Wisconsin Department of Transportation

<p>Proposal #02: 3803-00-65, WISC 2018 081 C Beaver Dam, North Spring Street W Maple Avenue to Mackie Street Loc Str Dodge County</p>	<p>3803-00-66 C Beaver Dam, North Spring Street W Maple Avenue to Mackie Street Loc Str Dodge County</p>
--	---

Letting of February 13, 2018

This is Addendum No. 01, which provides for the following:

Addendum No. 01
ID 3803-00-65
Revised Sheet 20
January 30, 2018

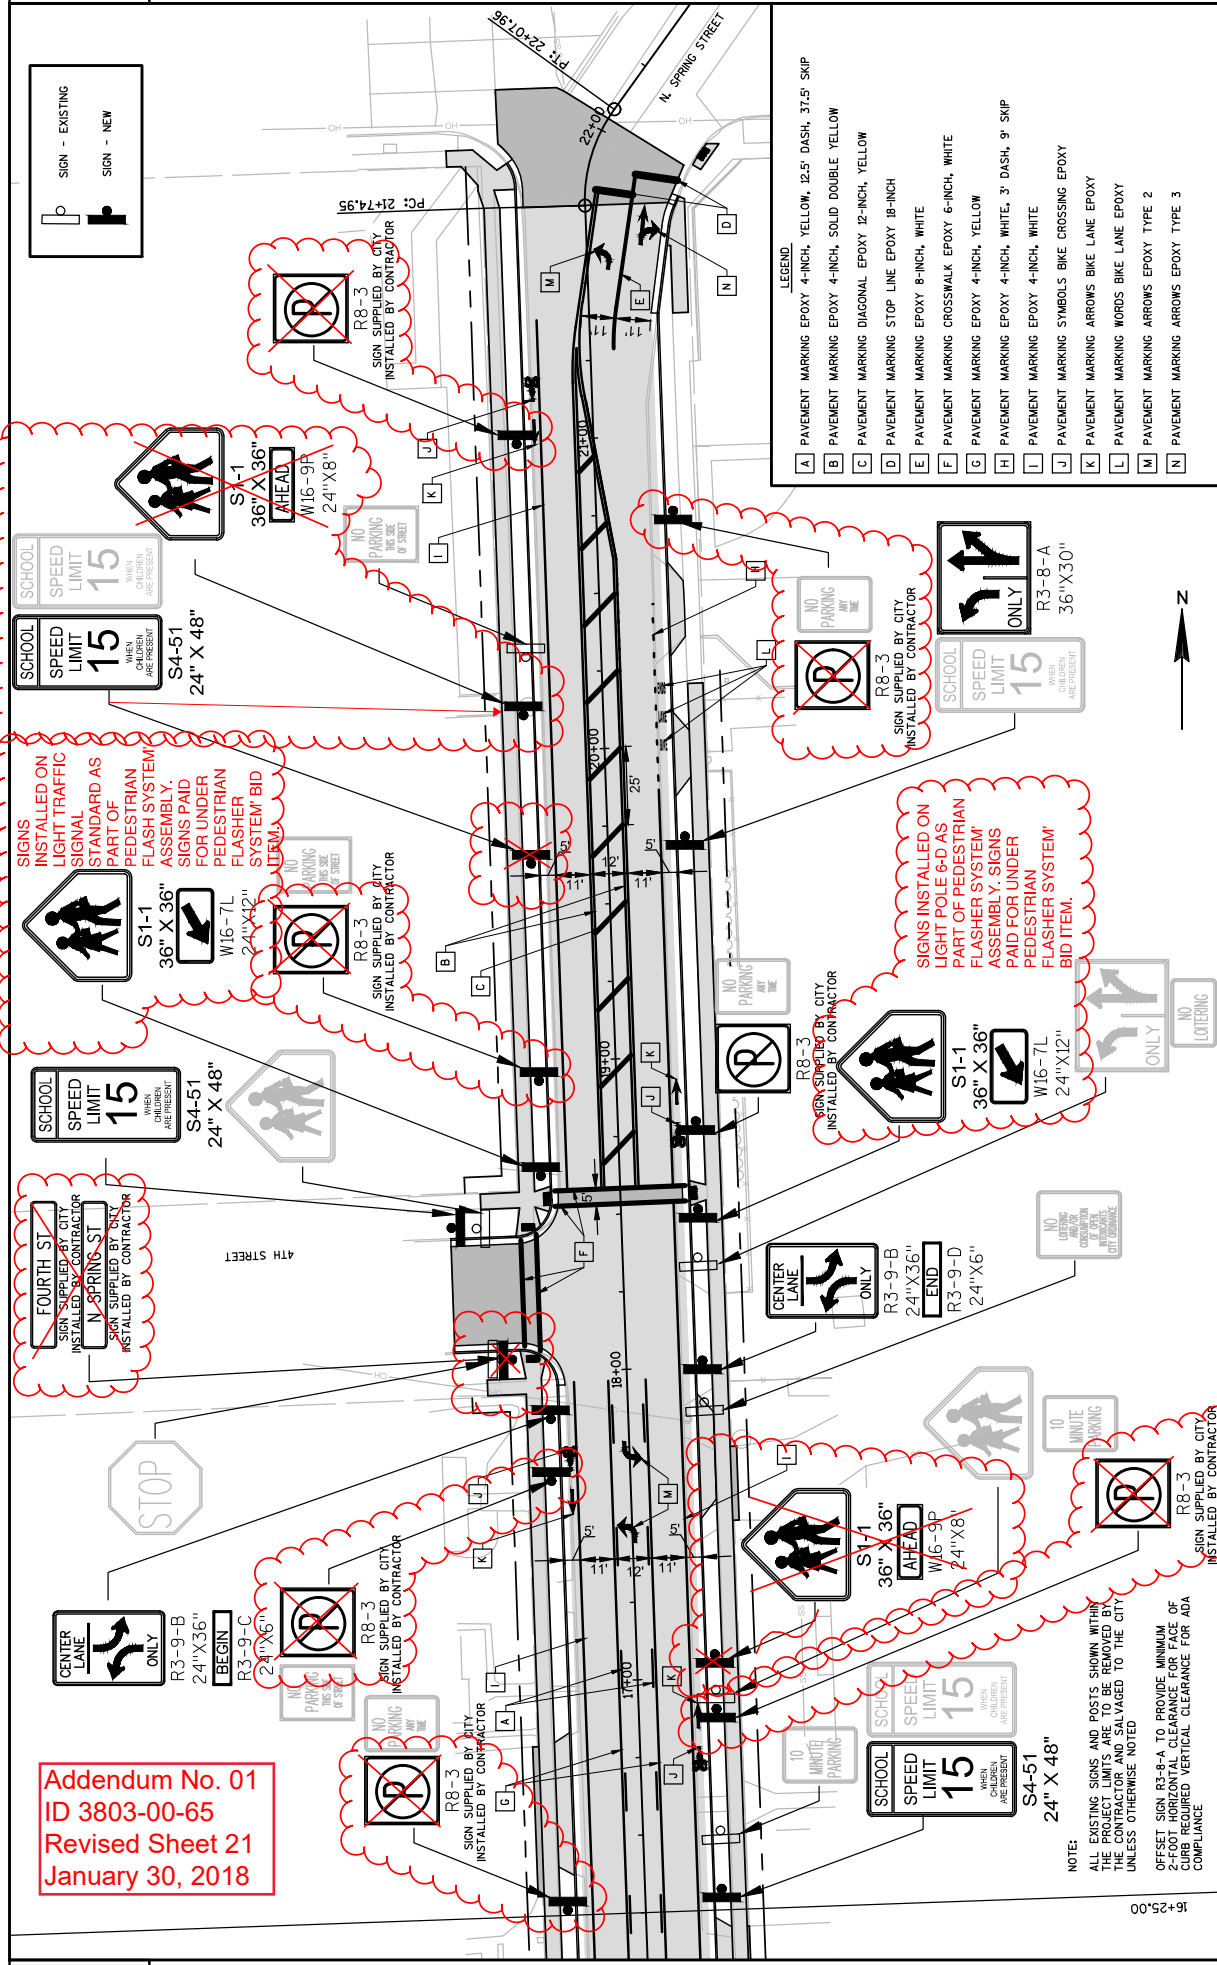
Revised Plan Sheets	
Plan Sheet	Plan Sheet Title (brief description of changes to sheet)
20	Permanent Signing and Pavement Markings (school zone signs were added and moved to appropriate locations, street name signs/no parking sign removed)
21	Permanent Signing and Pavement Markings (school zone signs were added and moved to appropriate locations, signs associated with the Pedestrian Flasher System were also clarified with no additional posts and paid for as part of the SPV, street name signs/no parking signs removed)
22	Street Lighting Plan (reference to the RRFB was removed the plan sheet and the additional RRFB pole and conduit was removed)
23	Street Lighting Plan (reference to the RRFB was removed the plan sheet)
37	Miscellaneous Quantities (added SPV.0060.28, U-Channel Sign Post 16-FT, added school zone signs, updated Yellow Diagonal Arrow sign code, updated signs and sign post quantities including removing U-Channel Sign Post 12-FT, SPV.0060.22)

Addendum No. 01
ID 3803-00-65
Revised Sheet 40
January 30, 2018

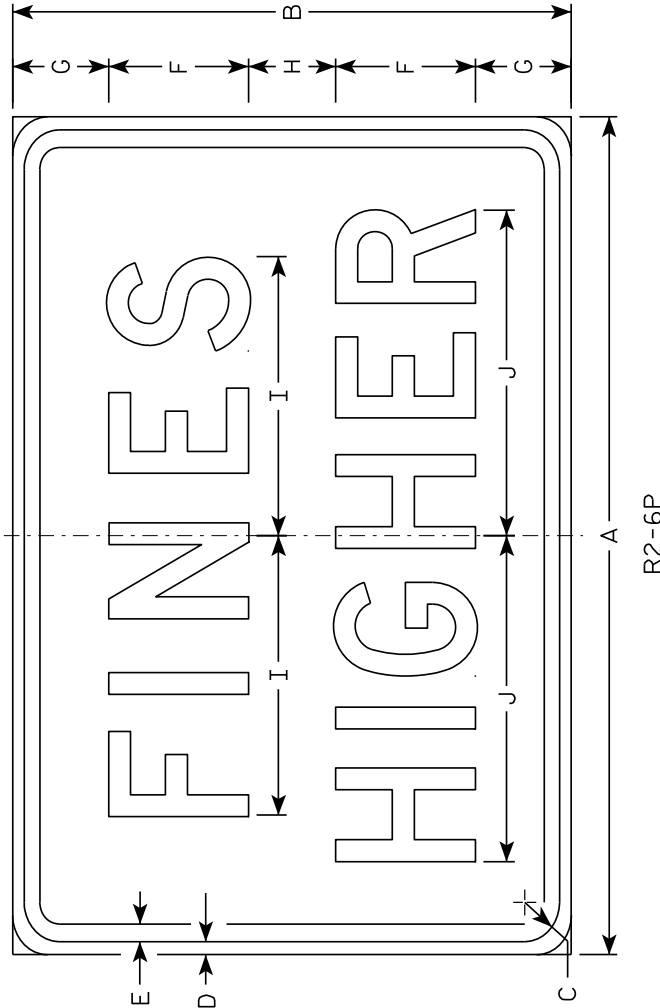
38	Miscellaneous Quantities (removed RRFB reference, updated light unit location and quantity, revised street name sign locations)
40	Miscellaneous Quantities (replaced reference from RRFB to Pedestrian Flasher System item with notes, removed Install City Furnished Street Signs, SPV.0060.05)
